M27 Southampton Junction 8  
Highways England  
Stage 2 Road Safety Audit

Document reference: HE551514-SWE-HGN-  
ZZ-RP-ZZ-50001

## Report Title                    Stage 2 Road Safety Audit

**Figure 4:14: Traffic signal heads on the Windhover roundabout circulatory near West End Road.**

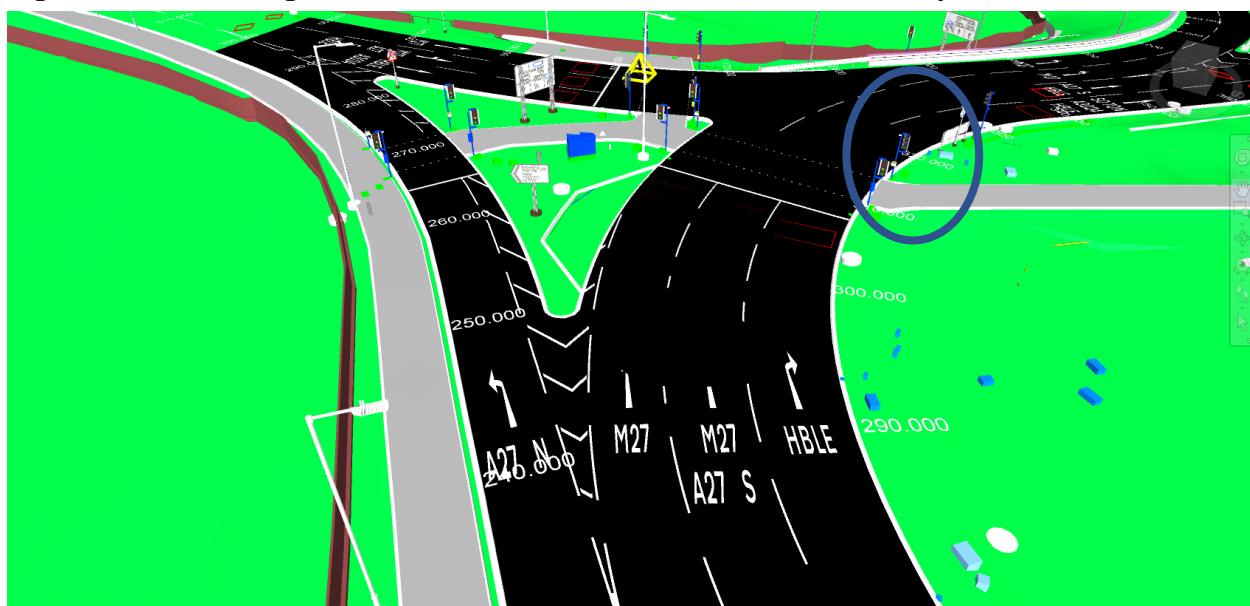
The Windhover roundabout circulatory includes a section of carriageway where the proposed traffic signal heads controlling the West End Road arm are located on the roundabout circulatory radius as shown in Figure 4.14. There is a danger therefore that the traffic signal heads are not clearly visible to circulating vehicles, particularly if the visibility to the traffic signal head on the nearside of the carriageway is masked by a stationary high sided vehicle. This may result in a circulating vehicle in lane 2 or lane 3 failing to note the traffic signals sufficiently enough in advance, therefore resulting in potential overshoot type crashes and conflicts with crossing vulnerable road users, or potential rear shunt type crashes with queuing vehicles.

It is recommended that a high signal head is provided at this location to help provide advanced information to approaching vehicles of the traffic light status ahead.

**Figure 4.16: Toucan crossings over Hamble Lane**

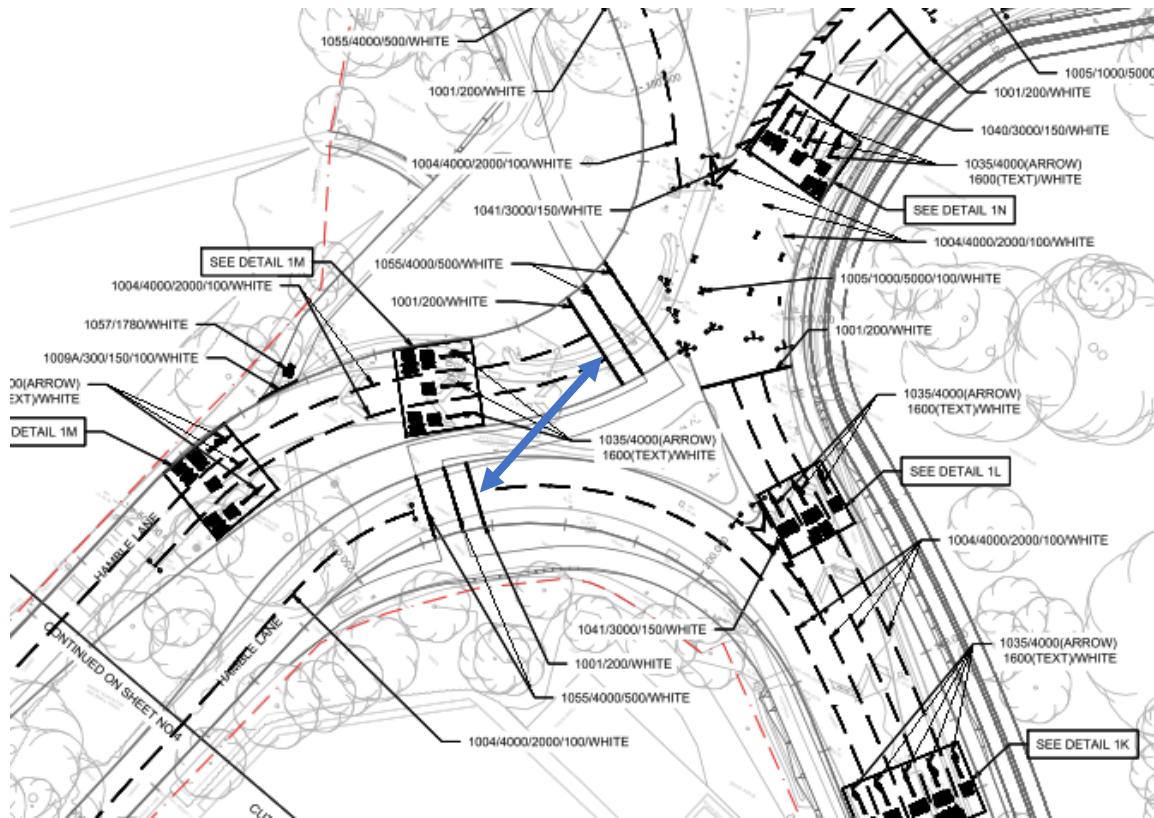
The proposed Toucan crossing over Hamble Lane east and westbound carriageways include a stagger within the central island between the two carriageway directions. This results in users heading between the north and south directions having to divert from the natural ‘straight ahead’ desire line to utilise the Toucan for each carriageway approach. This may result in some users avoiding the use of both of the Toucan crossings at this location, and instead crossing without signal control, thereby avoiding the need to divert from their assumed natural desire line. Crossing without the aid of signal control may increase the likelihood of vehicle strikes.

It is also noted at this location that there is a height difference between the east and westbound carriageway. The amendments to the infrastructure for vulnerable road users at this location may result in the introduction of a shared footway with a gradient which may result in an increased likelihood of slips for users, particularly when the surface is wet/icy, therefore increasing the likelihood of falls.

**Figure 4.17: Toucan crossings over Providence Hill**

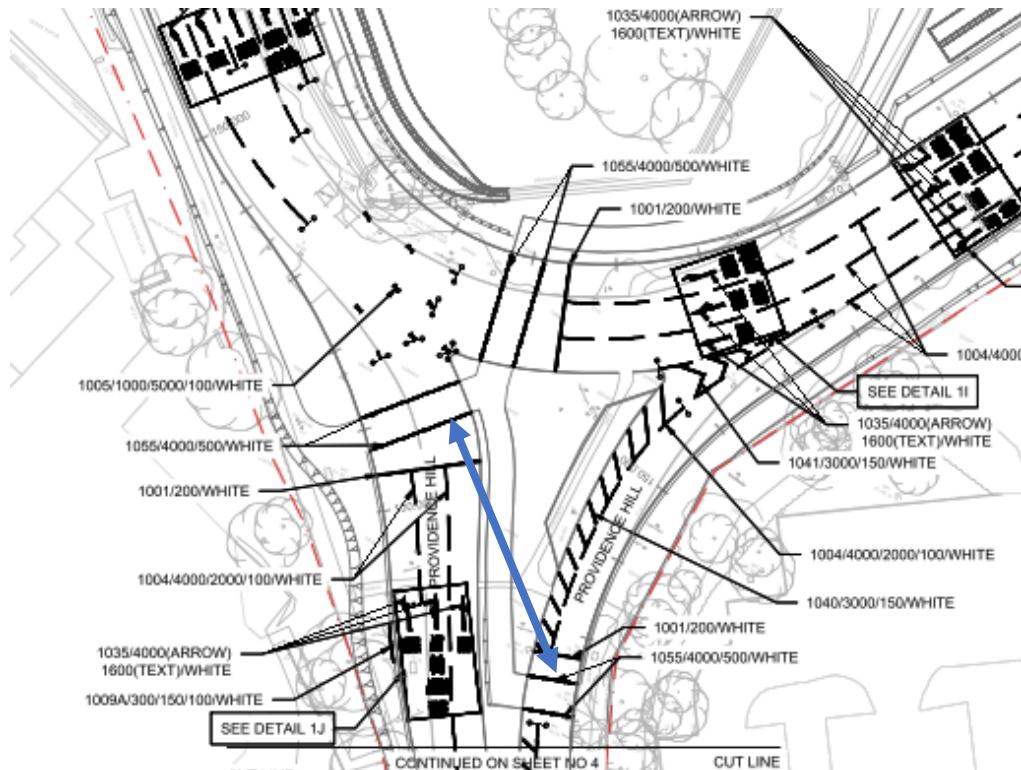
The proposed Toucan crossing over Providence Hill between north and southbound carriageways include a stagger within the central island between the two carriageway directions. This results in users heading between the east and west directions having to divert from the natural 'straight ahead' desire line to utilise the Toucan for each carriageway approach. This may result in some users avoiding the use of both of the Toucan crossings at this location, and instead crossing without signal control, thereby avoiding the need to divert from their assumed natural desire line. Crossing without the aid of signal control may increase the likelihood of vehicle strikes.

**Figure 4.19: Signage for cyclists on the southbound shared footway.**

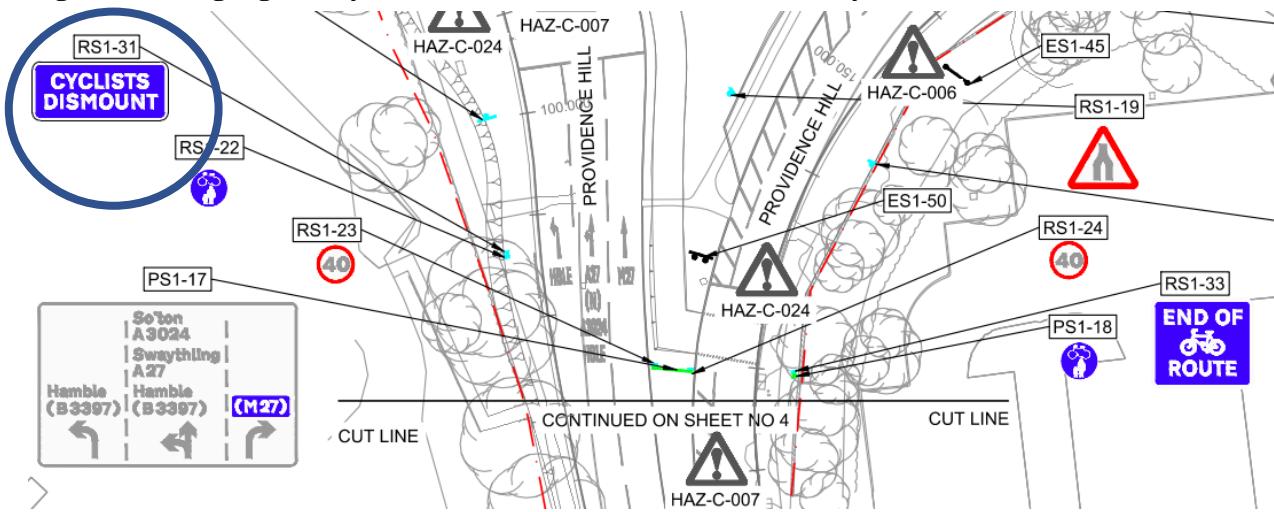
For cyclists heading southbound on the shared cycle facility on the westside of Providence Hill, there is no onward wayfinding information provided to users. Instead, a proposed sign instructing cyclists to dismount is included. This may result in confusion for cyclists unfamiliar with the location and may result in a lack of clarity on which onward route to select. Uncertainty on the correct onward route may result in confusion and the increased potential for conflicts.
